RE: FPL Riviera Beach Energy Center Project

Florida Power & Light Company (FPL) received the Florida Department of Environmental Protection Southeast District's (DEP) comments on the Riviera Beach Energy Center project dated May 6, 2009. FPL is pleased to provide herein to DEP the requested additional information.

Florida Power & Light Company
Riviera Beach Energy Center Project

Request for Additional information (RAI#1) for Permit Revision

Figure 4.5.0-1
Water Balance for RBEC
Fig 4.5.0-1.docx

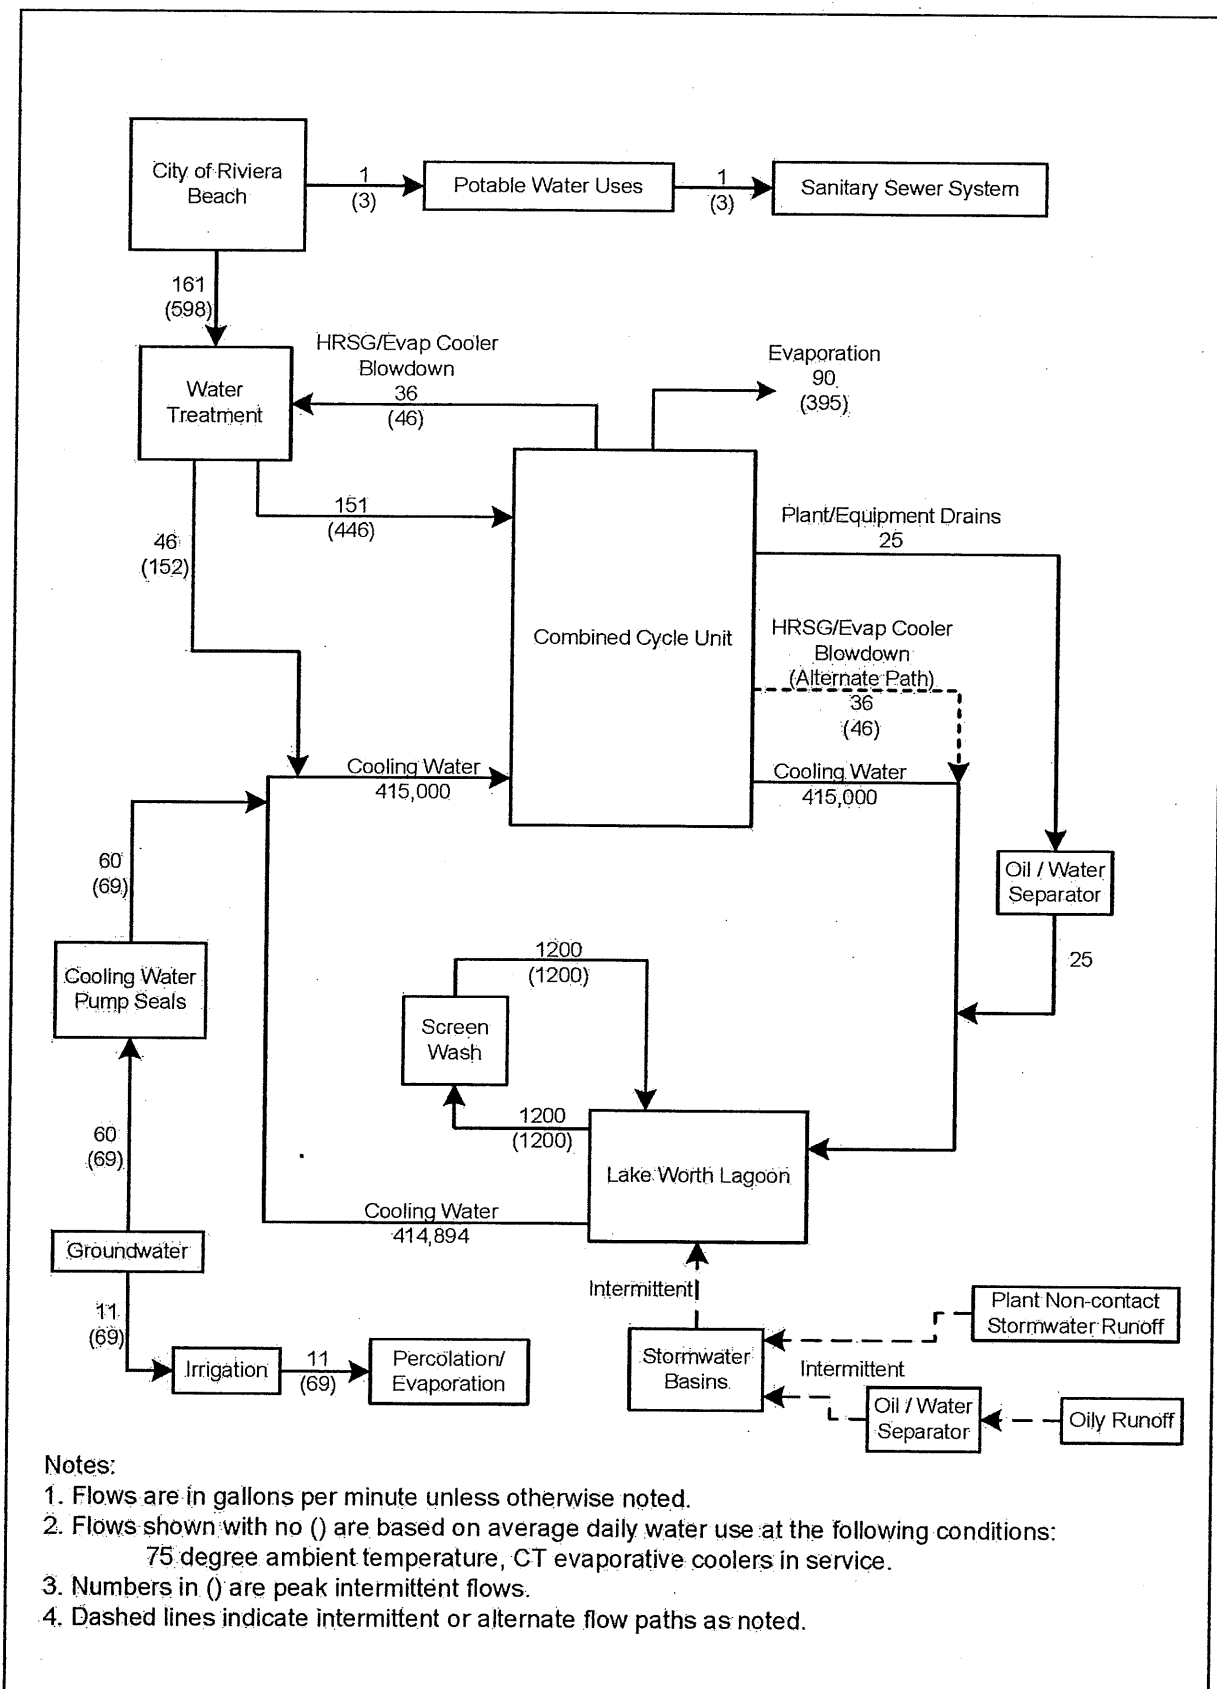
In Application Form 2CS, under the tables in Section I and IV.B, three new discharge streams - washwater/equipment drains at 25 gallons per minute (gpm); HRSG/evaporative cooler blowdown at 36 gpm; and R.O. reject at 46 gpm, are now being listed as discharges to occur at outfalls that are *To Be Determined (TBD)*. However, from reading Section 6.2, Effects of Chemicals and Biocide Discharges, in Volume I of the Site Certification Application report, and also the attachment to Section IV.B (or Attachment B-2) to Form 2CS, that these three discharge streams would either be reused as cooling water, or more likely, be discharged into (commingled with) the existing once-through cooling water discharge, to Outfalls D-013 and D-014, in order to attain the 1,000-to 2,000-to-1 dilution ratio.

As such, the discharge streams could now be identified in Section I of Form 2CS as “internal outfalls”, discharging internally to the streams tributary to the two existing Outfalls D-013 and D-014. The exact locations for the internal discharge locations may not yet be known, but their ultimate outfall locations, i.e., latitude/longitude coordinates, and with Lake Worth Lagoon being the receiving water, could already be indicated.

FPL has submitted revised pages 16, 17, and 18 of the 2CS form to FDEP Industrial Wastewater Section in Tallahassee as part of the responses to their request (included as ATTACHMENT 1 to this submittal), dated February 23, 2009, for additional information relative to FPL’s request to modify the NPDES Permit FL0001546. Copies of those pages are attached to this document. On revised page 2CS-16, Section I, we identify outfall I-TBD as discharging to Lake Worth Lagoon via internal outfall. On revised page 2CS-18, Part IV, outfall I-TBD is identified as Plant/Equipment Drains, with the actual number to be determined by the Department. On that same page, Outfall I-063/I-064 is identified as the R.O. reject (water treatment system wastewater) and HRSG/Evaporative Cooler blowdown discharge, and the correct latitude/longitude for Outfall I-0163/I-0164 is presented. Outfall I-063/I-064 is an existing internal discharge to the cooling water intake structure that presently delivers the existing plant water treatment system wastewater to be reused as cooling water. FPL intends to continue to discharge the similar water treatment system wastewater from the proposed RBEC to that location using the existing piping. FPL also intends to recycle the HRSG/Evaporative Cooler blowdown to the water treatment system for recycling as process water, with a secondary path to discharge via the Outfall I-0163/I-0164 on occasions when the water treatment system is unable to accept it for recycle. This secondary path will allow the HRSG/Evaporative Cooler blowdown to be reused as cooling water. All of the above information is consistent with the water use diagram presented as Attachment B-1 of the request to modify the NPDES Permit FL0001546 (included as ATTACHMENT 2 to this submittal), and the water use diagram presented in the SCA as Figure 4.5.0-1 (included as ATTACHMENT 3 to this submittal),.
